ATTACHMENT I TO IPN-91-040

PROPOSED TECHNICAL SPECIFICATION CHANGES  
RELATED TO  
PRESSURE-TEMPERATURE AND OVERPRESSURE  
PROTECTION SYSTEM LIMITS

NEW YORK POWER AUTHORITY  
INDIAN POINT 3 NUCLEAR POWER PLANT  
DOCKET NO. 50-286  
DPR-64

Figure 3.1.A-2

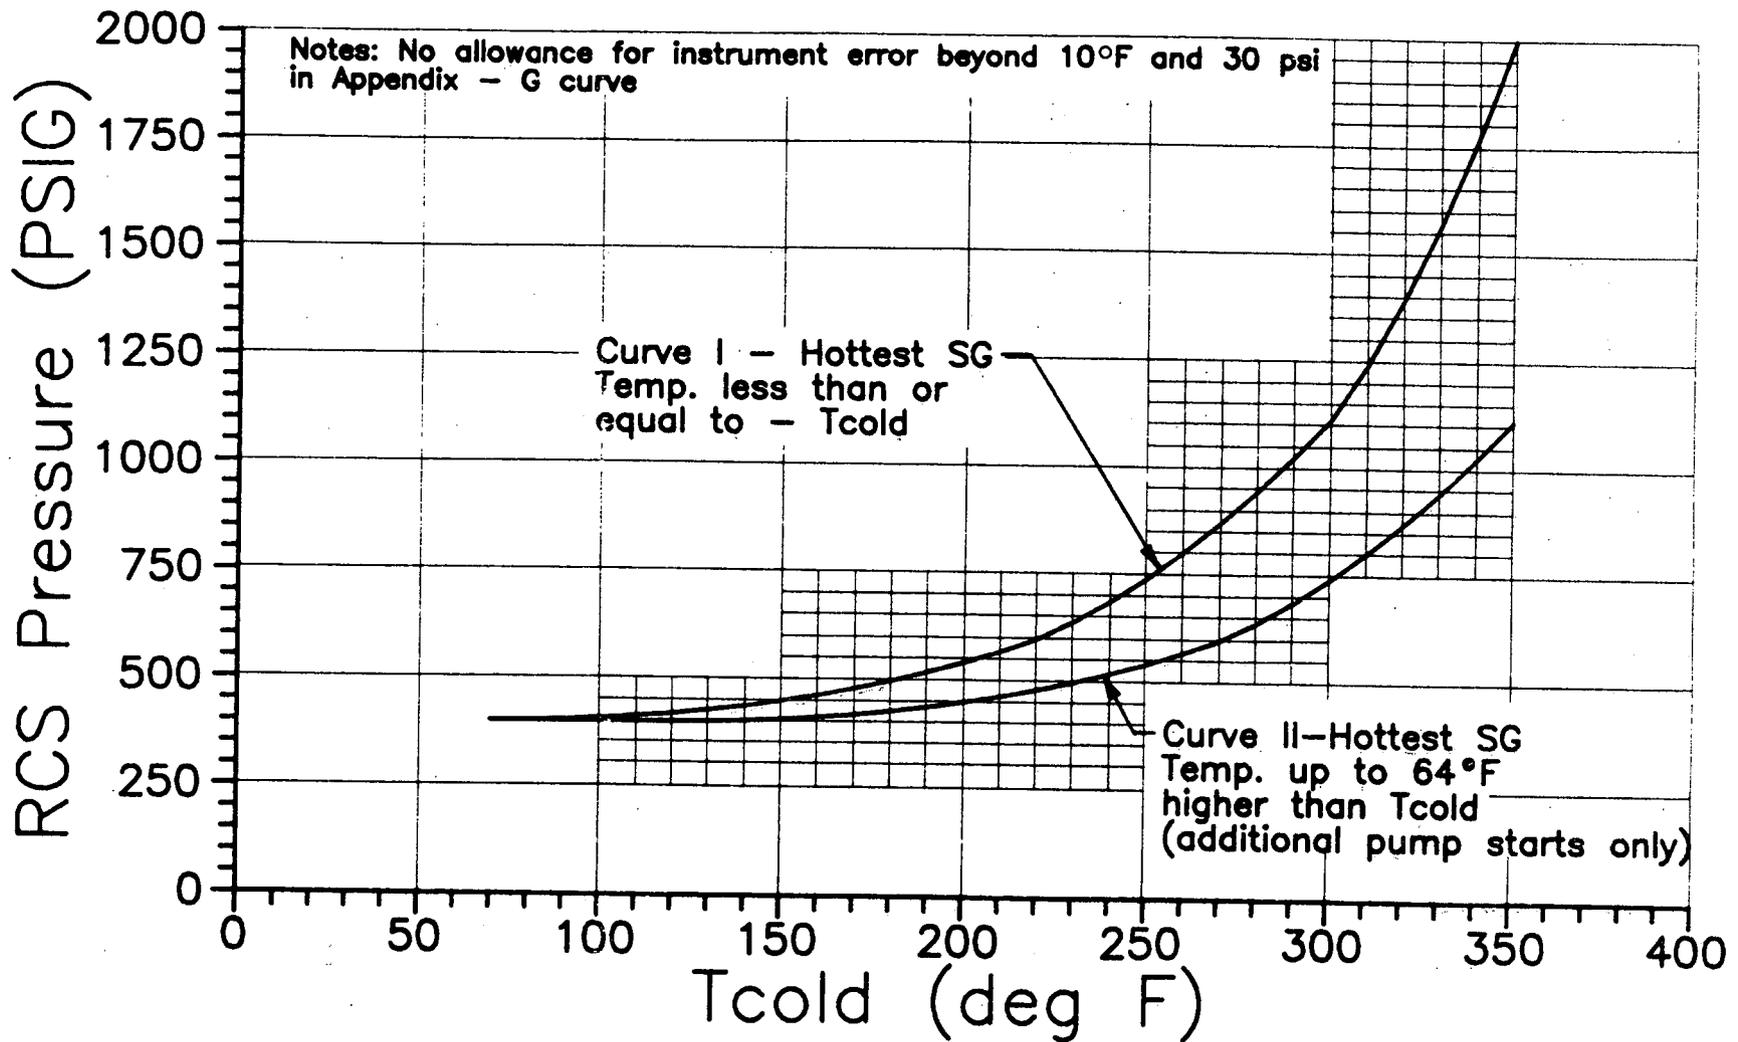
Or
  - (3) The OPS is inoperable, steam generator pressure is not decreasing, the temperature of each steam generator is less than or equal to the coldest  $T_{cold}$ , pressurizer level is at or below 75 percent, and the RCS pressure does not exceed that given by Curve I on Fig. 3.1.A-2;

- i. Additional pumps may not be started (or jogged) unless the OPS is operable and the pressurizer level is not increasing.
  - (1) Specification 3.1.A.1.i above may be modified to allow the OPS inoperable, providing the temperature of each steam generator has remained less than or equal to the coldest  $T_{cold}$  since the first RCP start, pressurizer level is at or below 75 percent and the RCS pressure does not exceed that given by Curve I on Fig. 3.1.A-2.
  - (2) Specification 3.1.A.1.i above may be further modified to allow the OPS inoperable and the temperature of the hottest steam generator to be no greater than 64°F higher than the coldest  $T_{cold}$ , provided that pressurizer level is at or below 75 percent and RCS pressure does not exceed that given by Curve II on Fig. 3.1.A-2.

Figure 3.1.A-3

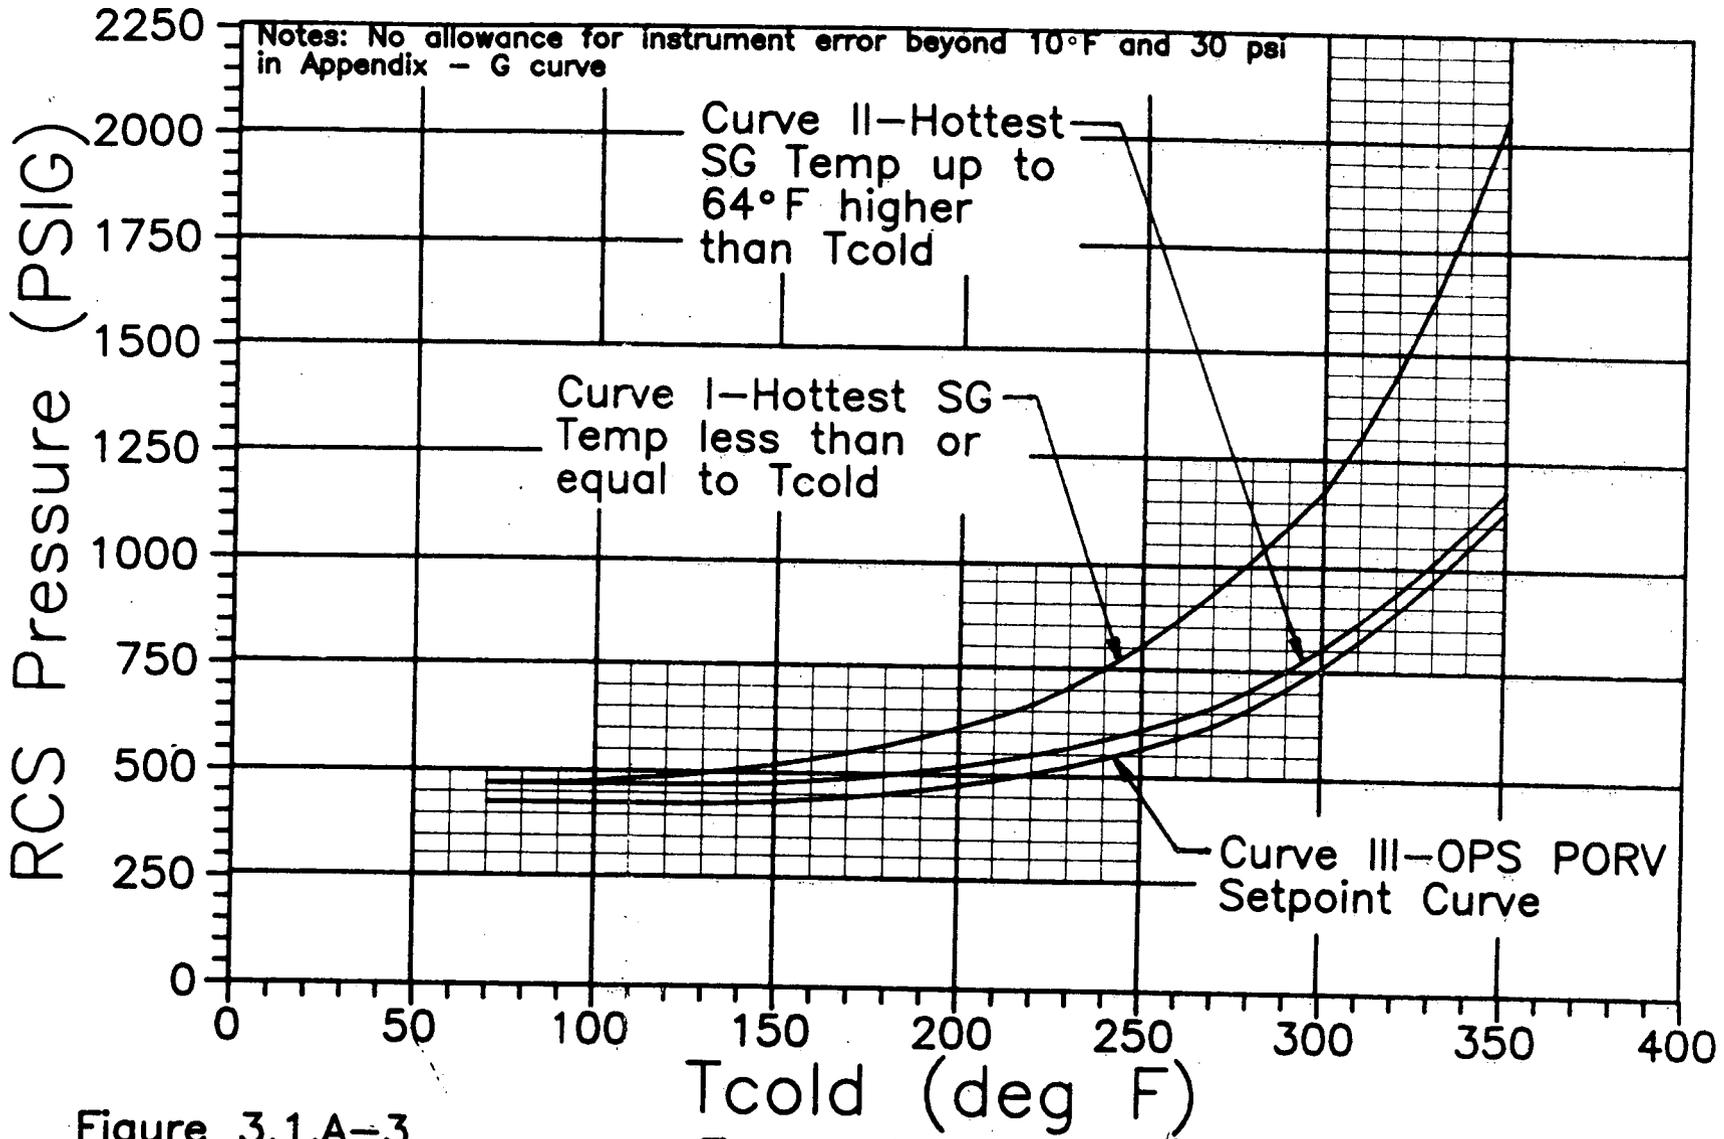
- j. Following the start of one or more RCP's and prior to reaching 332°F, the RCS pressure shall not exceed that given by Curves I and II on Fig. 3.1.A-3 as appropriate.

a. When the RCS temperature is below 332°F and the RCS is not depressurized and vented with an equivalent opening of at least 2.00 square inches, the OPS shall be "armed" and "operable". Both OPS PORVs shall have lift settings not to exceed those given by Curve III (OPS PORV setpoint limit curve) on Fig. 3.1.A-3.

Figure 3.1.A-5

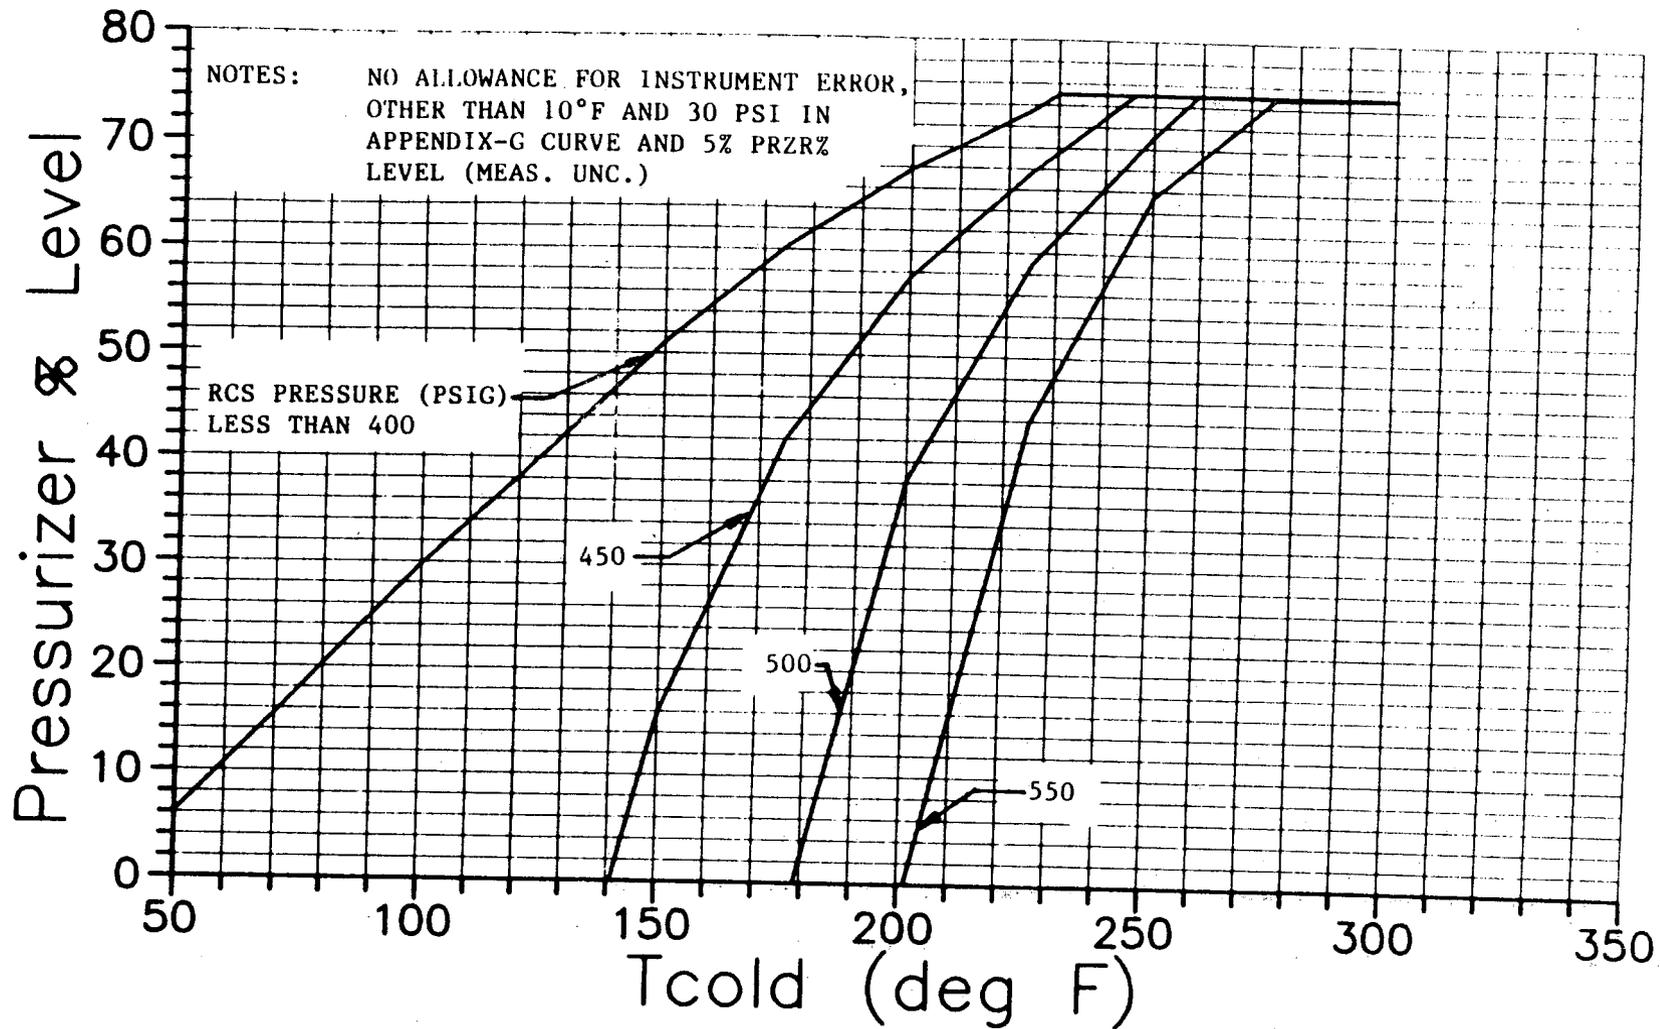
For up to 1 charging pump in operation with no SI pumps energized and aligned to feed the Reactor Coolant System, see Fig. 3.1.A-5.

Figure 3.1.A-6

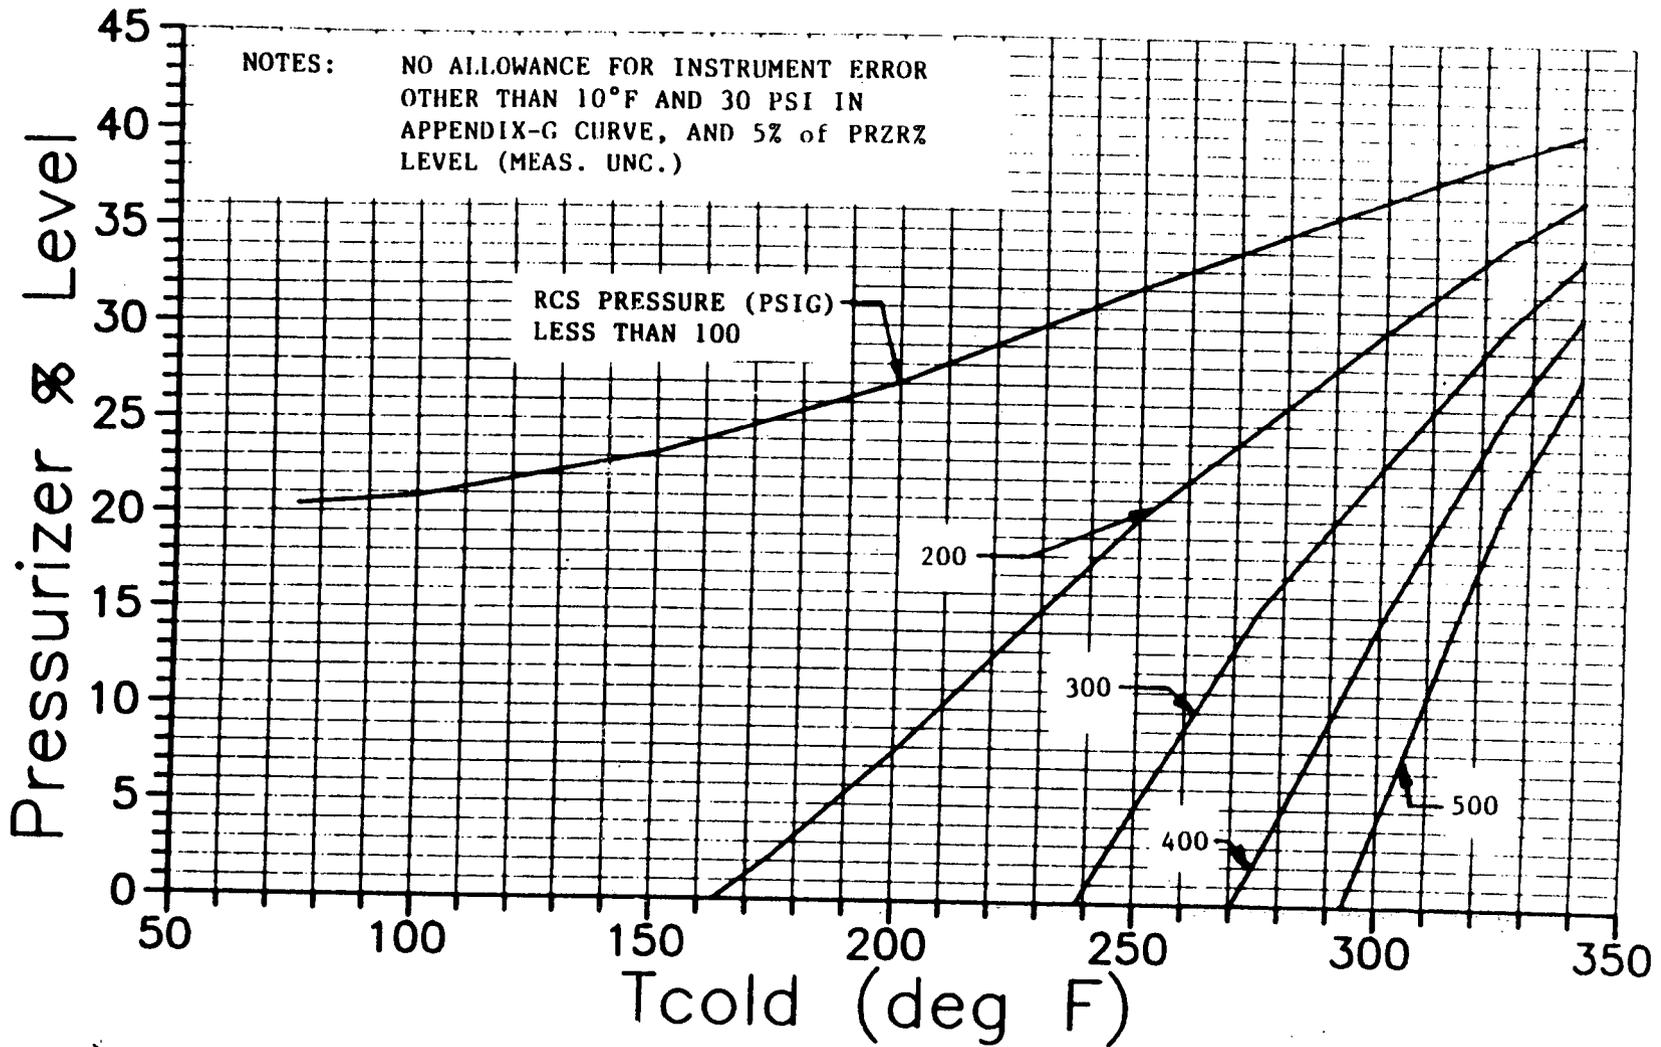
For up to 3 charging pumps in operation concurrent with up to 1 SI pump energized and aligned to feed the Reactor Coolant System, see Fig. 3.1.A-6.

REACTOR COOLANT SYSTEM HEATUP LIMITATIONS - INDIAN POINT 3

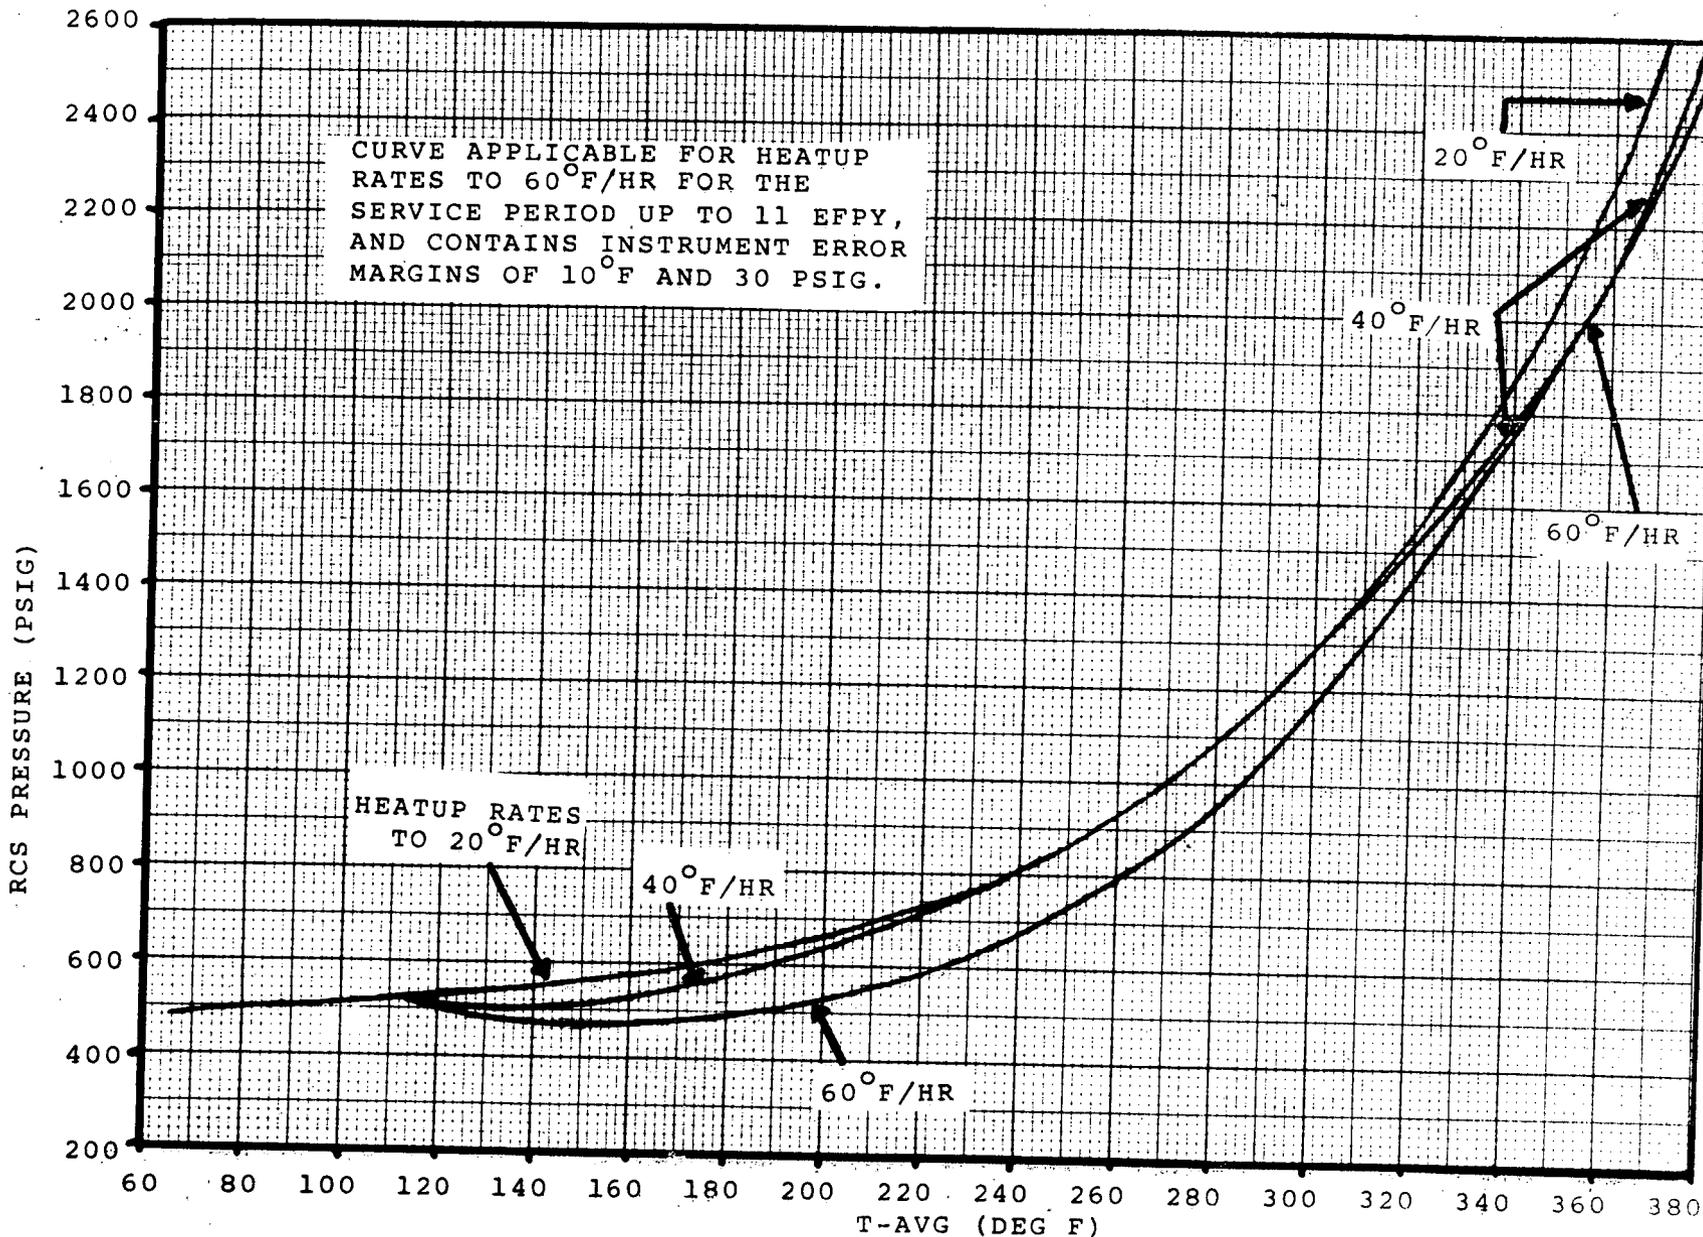
1. The reactor coolant temperature and pressure and system heatup and cooldown rates averaged over one hour (with the exception of the pressurizer) shall be limited in accordance with Figure 3.1-1 and Figure 3.1-2 for the service period up to 11.00 effective full-power years (EFPYs). The heatup and cooldown rates shall not exceed 60°F/hr and 100°F/hr respectively.

The first reactor vessel material surveillance capsule was removed during the 1978 refueling outage. This capsule has been tested by Westinghouse Corporation and the results have been evaluated and reported <sup>(7)</sup>. Similar reports were prepared for the surveillance capsules <sup>(10, 8)</sup> removed in 1982 and 1987. Based on the Westinghouse evaluation, heatup and cooldown curves (Figures 3.1-1 and 3.1-2) were developed for up to 11.00 EFPYs of reactor operation.

The maximum shift in  $RT_{NDT}$  after 11.00 EFPYs of operation is projected to be 202°F at the 1/4 T and 163°F at the 3/4 T vessel wall locations for Plate B2803-3 the controlling plate. Plate B2803-3 was also the controlling plate for the operating period up to 9.00 EFPYs.

Heatup and cooldown limit curves are calculated using the most limiting value of  $RT_{NDT}$  at the end of 11.00 years of service life. The 11.00 year service life period is chosen such that the limiting  $RT_{NDT}$  at the 1/4 T location in the core region is higher than the  $RT_{NDT}$  of the limiting unirradiated material. This service period assures that all components in the Reactor Coolant System will be operated conservatively in accordance with Code recommendations.
